### Amendment C245 Queen Victoria Market Precinct Renewal

26 July 2016

**Panel Report**

# Melbourne Planning Scheme Amendment C245 Queen Victoria Market built form controls

FIGURE 1: QUEEN VICTORIA MARKET PRECINCT FRAMEWORK PLAN 2016

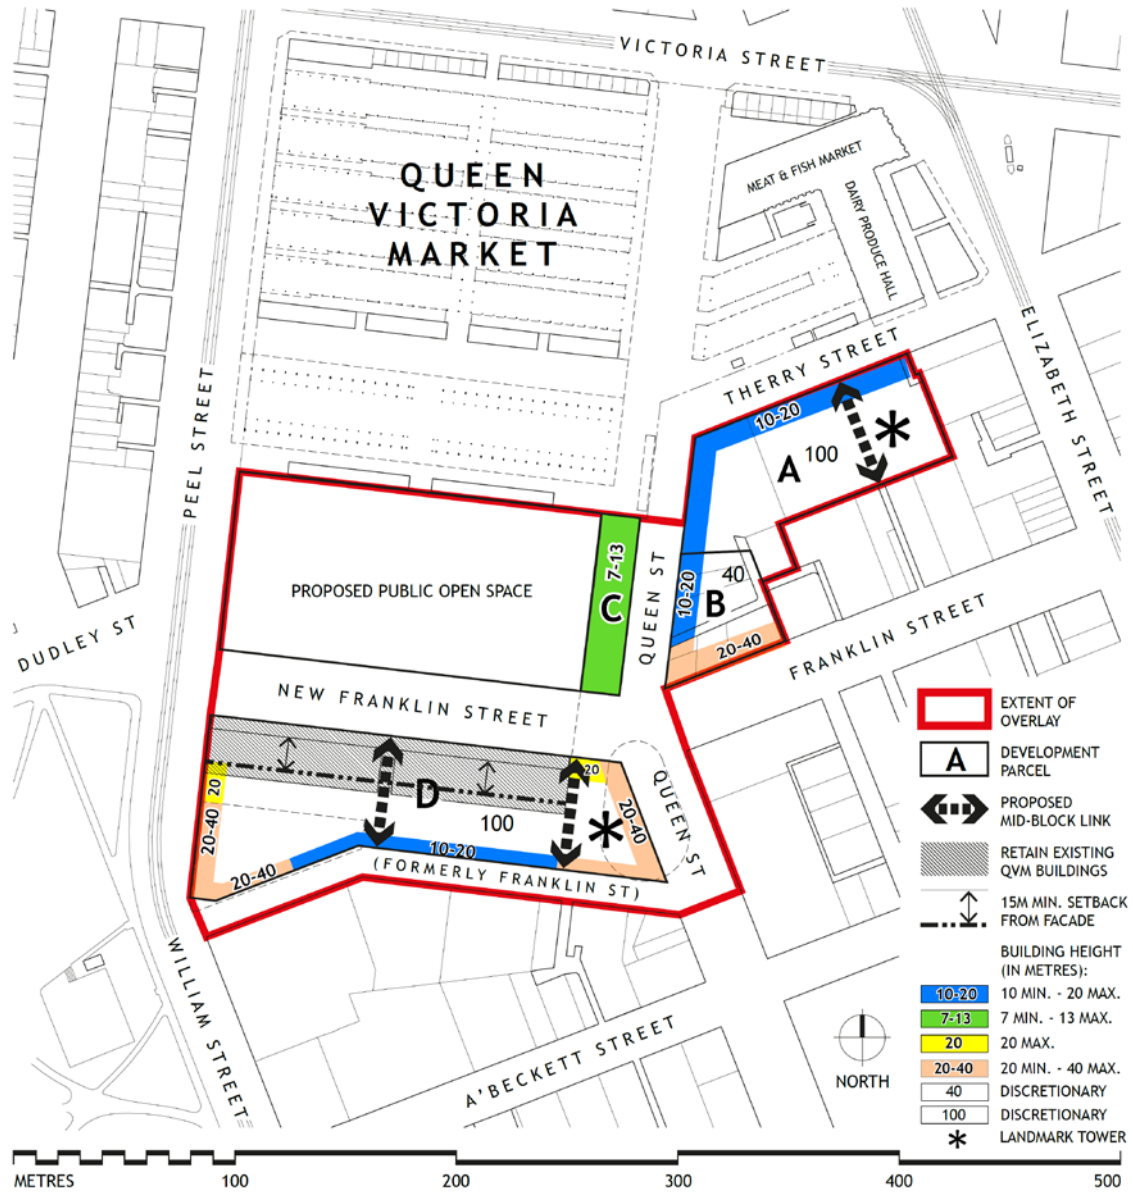
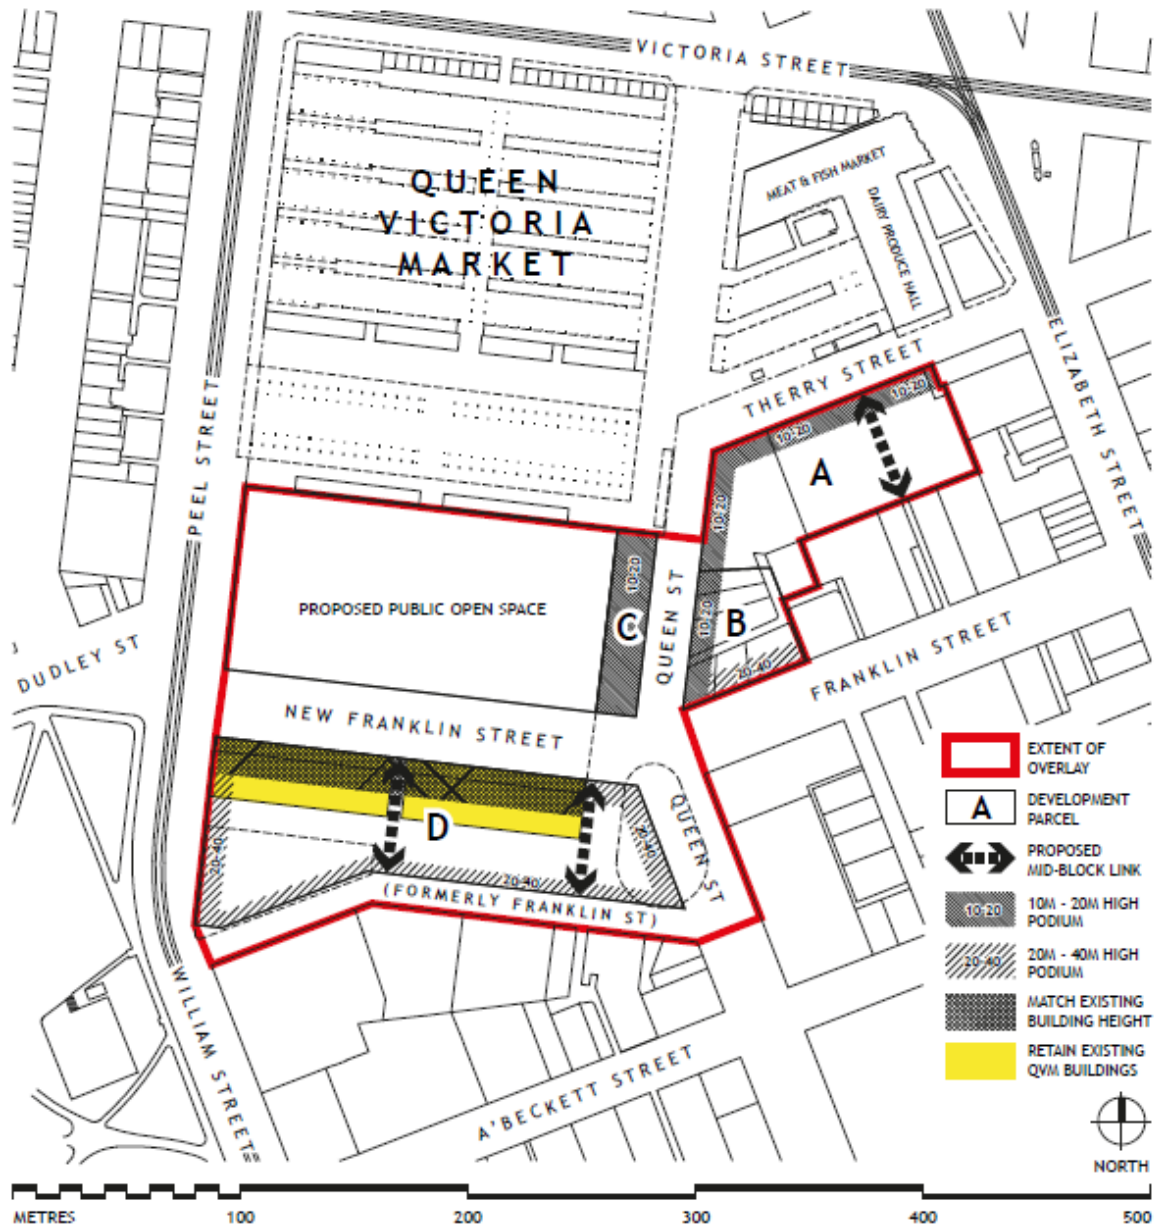
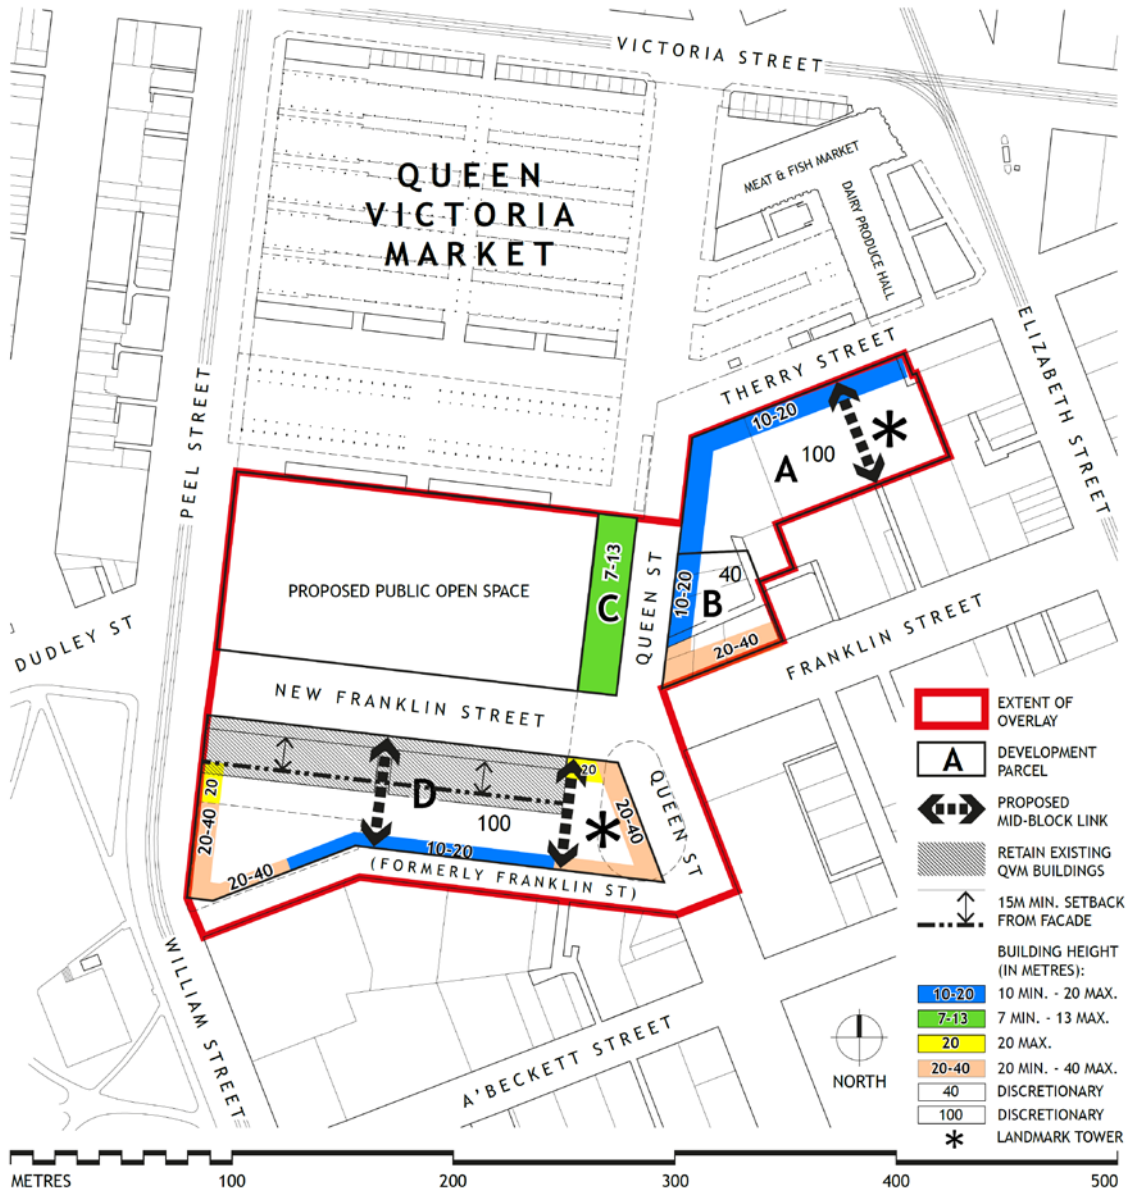
- 1. Amend the Framework Plan at Figure 1 of the Development Plan Overlay Schedule 11 as follows:**
  - a) Include a discretionary overall height limit of 100 metres for Parcel A and 40 metres for Parcel B.**

- b) Require a mandatory 10 metre tower setback from the front of podium to Therry Street and Queen Street, in Parcel A as shown in Figure 1.**
  - c) Provide for a discretionary 20 metre minimum podium height and require a mandatory 40 metre podium height for the property located at the corner of Queen Street and Franklin Street.**

- d) Provide for a discretionary 10 metre tower setback from the front of podium to Queen Street for Parcel B, as shown in Figure 1. Alternatively, a mandatory 5 metre front setback could also be specified.**

- e) Require a mandatory 5 metre tower setback from the front of podium to Franklin Street for Parcel B, as shown in Figure 1.**
  - f) Require a mandatory 5 metre side and rear tower setback from boundaries or the centre of a laneway, rather than the 10 metres as proposed.**

3. Amend the Framework Plan at Figure 1 and Conditions and Requirements for permits of the Development Plan Overlay Schedule 11 to provide for a discretionary height limit of 7 metres and require a mandatory maximum height of 13 metres to Parcel C.

- Pedestrian permeability and connectivity through the building from Queen Street to the open space and Queen Victoria Market beyond.
  5. Amend the Framework Plan at Figure 1 of the Development Plan Overlay Schedule 11 for Parcel D as follows:

PANEL RECOMMENDATION	ACCEPT/REJECT	MANAGEMENT RESPONSE
<b>Development Plan Overlay Schedule 11 (DPO11)</b>			
1.	<p>Amend the Framework Plan at Figure 1 of the Development Plan Overlay Schedule 11 as follows:</p> <ul style="list-style-type: none"> <li>a) Include a discretionary overall height limit of 100 metres for Parcel A and 40 metres for Parcel B.</li> <li>b) Show podium height of 20 metre minimum to 40 metre maximum on the property located at the north east corner of Queen Street and Franklin Street.</li> <li>c) Show the location for greatest height being towards the Elizabeth Street end of the Parcel A, to the east of the proposed through block link.</li> </ul>	Accept	<p><i>Discussion:</i></p> <p>Provisions have been included to specify preferred heights in DPO11.</p> <p>Provisions have also been included to increase the development capacity of Parcel B which is slightly more removed from the Market than Parcel A, the Council owned land.</p> <p><i>Recommendation:</i></p> <p>The Framework Plan at Figure 1 of the DPO11 has been amended to reflect the recommendations of the Panel.</p>

<p>experience.</p> <ul style="list-style-type: none"> <li>b) Require a mandatory 10 metre tower setback from the front of podium to Therry Street and Queen Street, in Parcel A as shown in Figure 1.</li> <li>c) Provide for a discretionary 20 metre minimum podium height and require a mandatory 40 metre podium height for the property located at the corner of Queen Street and Franklin Street.</li> <li>d) Provide for a discretionary 10 metre tower setback from the front of podium to Queen Street for Parcel B, as shown in Figure 1. Alternatively, a mandatory 5 metre front setback could also be specified.</li> <li>e) Require a mandatory 5 metre tower setback from the front of podium to Franklin Street for Parcel B, as shown in Figure 1.</li> <li>f) Require a mandatory 5 metre side and rear tower setback from boundaries or the centre of a laneway, rather than the 10 metres as proposed.</li> <li>g) Require a mandatory tower separation distance to apply to 'towers within a site', or from 'existing or approved towers on adjoining sites'.</li> <li>h) For Parcel B, provide for 0 metre side and rear setbacks up to a building height of 40 metres, where it can be demonstrated this will not cause an unreasonable impact on the future development potential or amenity of neighbouring properties.</li> <li>i) Nominate a discretionary height limit of 100 metres for Parcel A and 40 metres for Parcel B. Any application to exceed this height should be supported by 3D modelling and an assessment of the visual impact on the open space and public realm.</li> </ul>		<p>have been increased to a discretionary 20 metre minimum and a mandatory 40 metre maximum and the podium setback from Queen Street has been made discretionary. This parcel may also have 0 metre side and rear setbacks up to a building height of 40 metres, where it can be demonstrated this will not cause an unreasonable impact on the future development potential or amenity of neighbouring properties.</p> <p>Parcel A which is owned by Council is subject to a 100 metre discretionary height control.</p> <p><i>Recommendation:</i></p> <p>The Conditions and Requirements for permits in the DPO11 have been amended to reflect the recommendations of the Panel.</p>

3.	Amend the Framework Plan at Figure 1 and Conditions and Requirements for permits of the Development Plan Overlay Schedule 11 to provide for a discretionary height limit of 7 metres and require a mandatory maximum height of 13 metres to Parcel C.	Accept	<p><i>Discussion:</i></p> <p>The maximum height of the proposed Queens Corner building has been lowered to a maximum of 13 metres to be more sympathetic to the new open space.</p> <p><i>Recommendation:</i></p> <p>The Framework Plan at Figure 1 of the DPO11 has been amended to reflect the recommendations of the Panel.</p>
----	---	--------	--

5.	<p>5. Amend the Framework Plan at Figure 1 of the Development Plan Overlay Schedule 11 for Parcel D as follows:</p> <ol style="list-style-type: none"> <li>a) Show the podium setback from the north façade of the heritage listed Stores Buildings (towers facing new Franklin Street) as a mandatory minimum of 15 metres.</li> <li>b) Show Podium heights on New Franklin Street where they abut the heritage listed Stores Building are to be a mandatory maximum height of 20 metres.</li> <li>c) Show podium height on former Franklin Street between William and Queen Streets to be a discretionary 10 metre minimum and require mandatory 20m maximum, except at the ends of the block as shown in the framework plan where podiums are to be a discretionary minimum 20 metre to mandatory 40 metre maximum.</li> </ol>	Accept	<p><i>Discussion:</i></p> <p>Parcel D is the newly created parcel that will vest in Council.</p> <p>Revised provisions have been included to ensure new development responds sympathetically to the Stores building which is part of the Heritage Registered area.</p> <p>Because New Franklin Street is narrow reduced podium heights (except at block) ends to allow more light to the street have been included.</p> <p><i>Recommendation:</i></p>

The Framework Plan at Figure 1 of the DPO11 has been amended to reflect the recommendations of the Panel.
6.	<p>Amend 'Conditions and requirements for permits' in Development Plan Overlay Schedule 11 as follows:</p> <ul style="list-style-type: none"> <li>a) Require podiums fronting New Franklin Street where they abut the heritage listed Stores Buildings to have a mandatory maximum podium height of 20 metres.</li> <li>b) Remove the reference to a cantilever built form over the rear of the heritage listed Stores Buildings</li> <li>c) Require Podiums fronting Little Franklin Street between William Street and Queen Street should have a mandatory maximum podium height of 20 metres, except at the block ends as shown in the framework plan where podiums should have a discretionary minimum podium height of 20 metres and must have a mandatory maximum podium height of 40 metres.</li> <li>d) Require mandatory tower setbacks for towers facing new Franklin Street to be a mandatory minimum of at least 15 metres behind the northern masonry facades of the existing sheds.</li> <li>e) Require a mandatory 10m tower separation distance to apply to 'towers within a site', or from 'existing or approved towers on adjoining sites'.</li> <li>f) Nominate a discretionary overall height limit of 100 metres for Parcel D and with the location for greatest height being towards the Queen Street end of the Parcel D. Any application to exceed this height should be supported by 3D modelling and an assessment of the visual impact on the open space and public realm</li> </ul>	Accept	<p><i>Discussion:</i></p> <p>Revised provisions have been included to ensure new development responds sympathetically to the Stores building which is part of the Heritage Registered area. This includes a discretionary overall height limit of 100 metres for parcel D.</p> <p>Because New Franklin Street is narrow reduced podium heights (except at block ends) allow more light to the street.</p> <p><i>Recommendation:</i></p> <p>The Conditions and Requirements for permits in the DPO11 have been amended to reflect the recommendations of the Panel.</p>
